Topical Report DPC-NE-2003, Revision 1

DUKE POWER COMPANY
OCONEE NUCLEAR STATION
CORE THERMAL-HYDRAULIC METHODOLOGY
USING VIPRE-01

Revision 1 Submitted: February 2000

Subject: Oconee Nuclear Station, Docket Numbers 50-269, -270, and -287
Topical Report EPC-NE-2003, "Core Thermal-Hydraulic Methodology
Using VIPRE-01"; Response To Request For Additional Information

FIGURE 1.

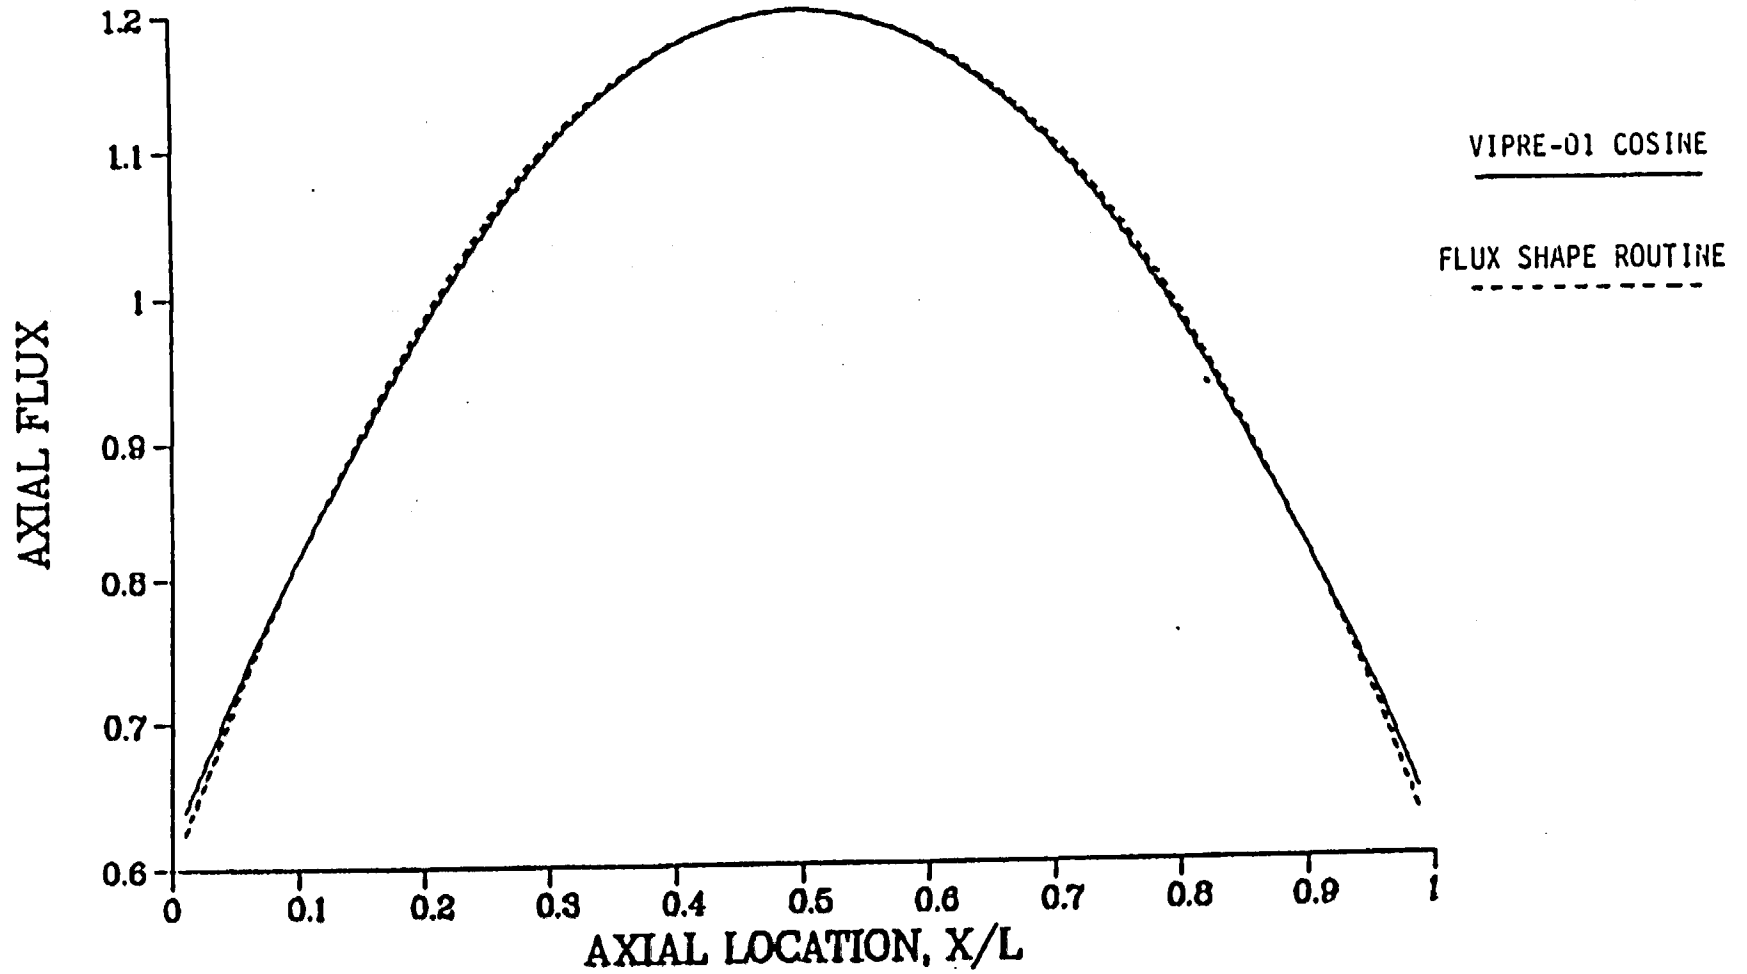
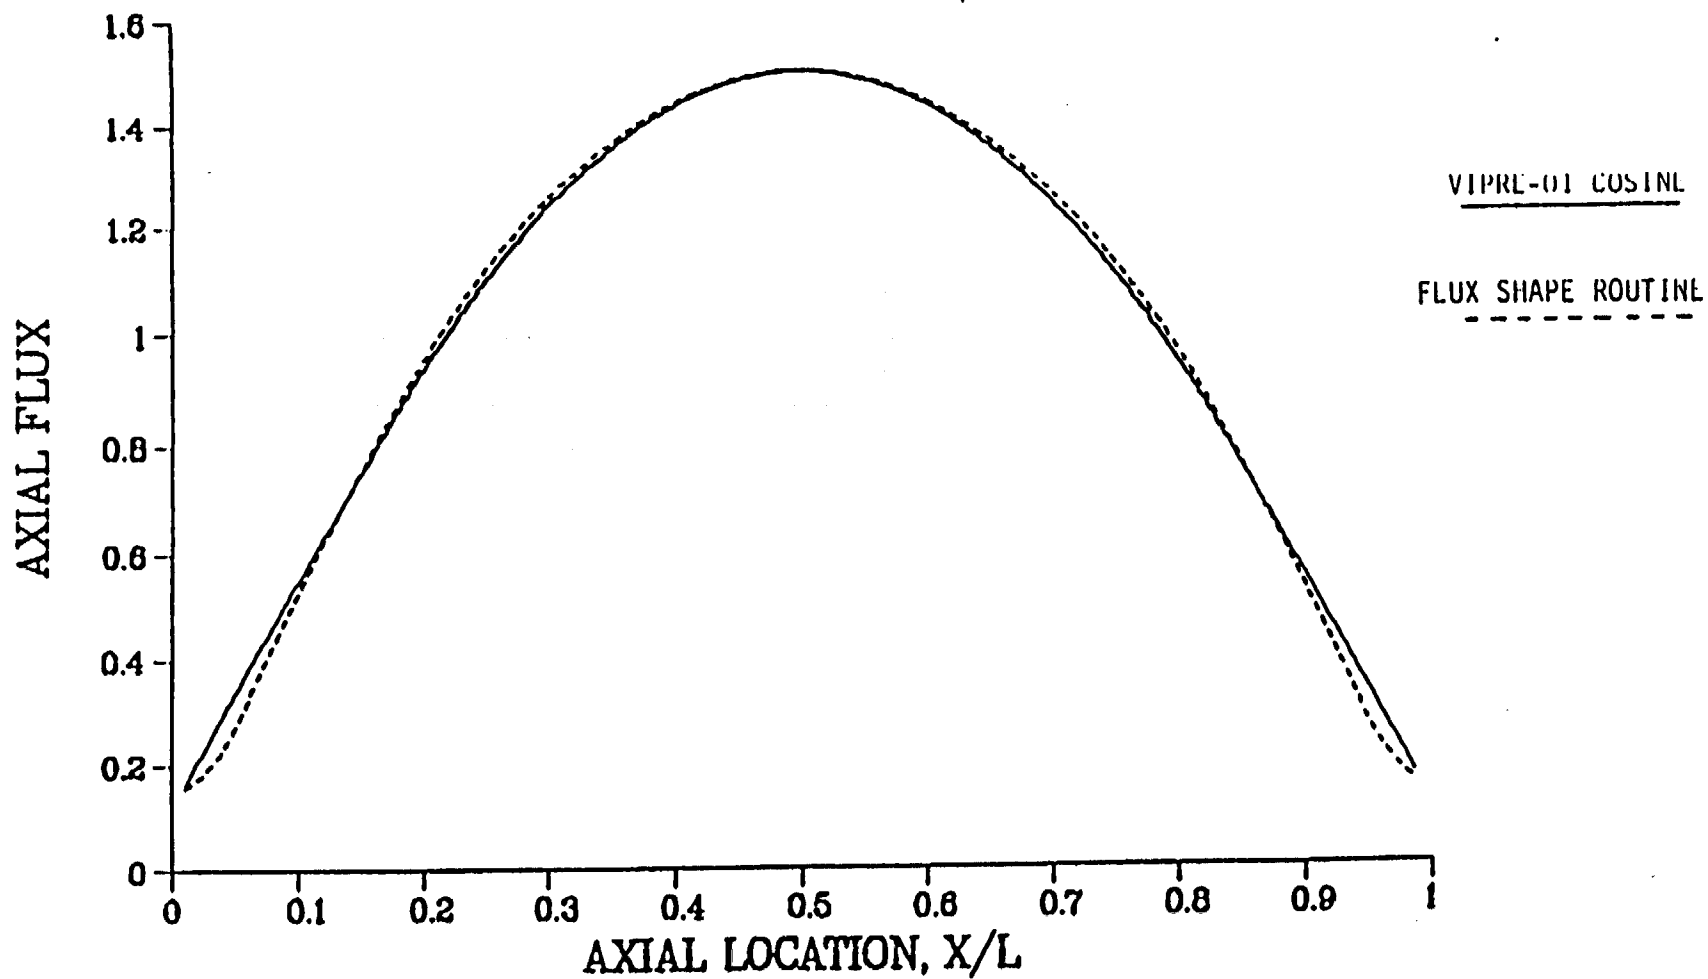
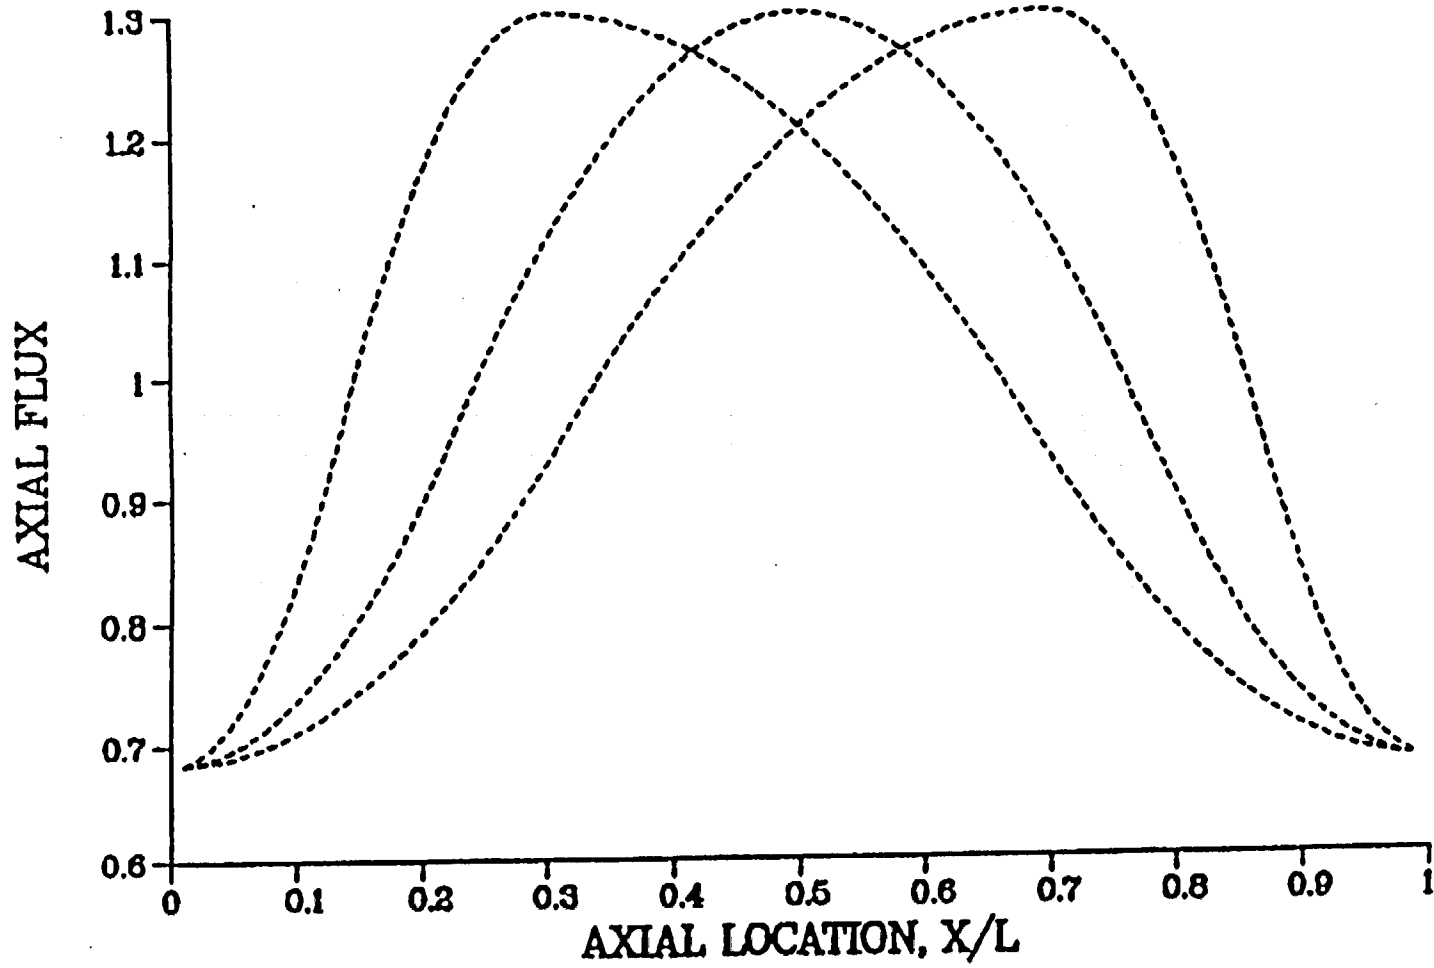
Question 5.

Section 5.10 states that a new routine is added to the VIPRE-01 code to generate axial power shapes with inlet, symmetric, or outlet peaks. Provide sufficient details of this routine.

The axial power shape routine added to VIPRE-01 is based on the following mathematical constraints on an axial power shape:

figures clearly show the agreement between the two methods of generating symmetric axial flux shapes. The new flux shape routine was added to generate skewed axial flux shapes. As discussed in Section 6.5 of the topical report, Maximum Allowable Peaking (MAP) limits are calculated for a range of axial peaks with the location of the peak varied from the bottom to the top of the core. As an example of the flux shapes used to calculate the MAP limits, three axial shapes are shown in Figure 3 for an axial peak of 1.3 at $X/L = 0.3, 0.5, \text{ and } 0.7$.
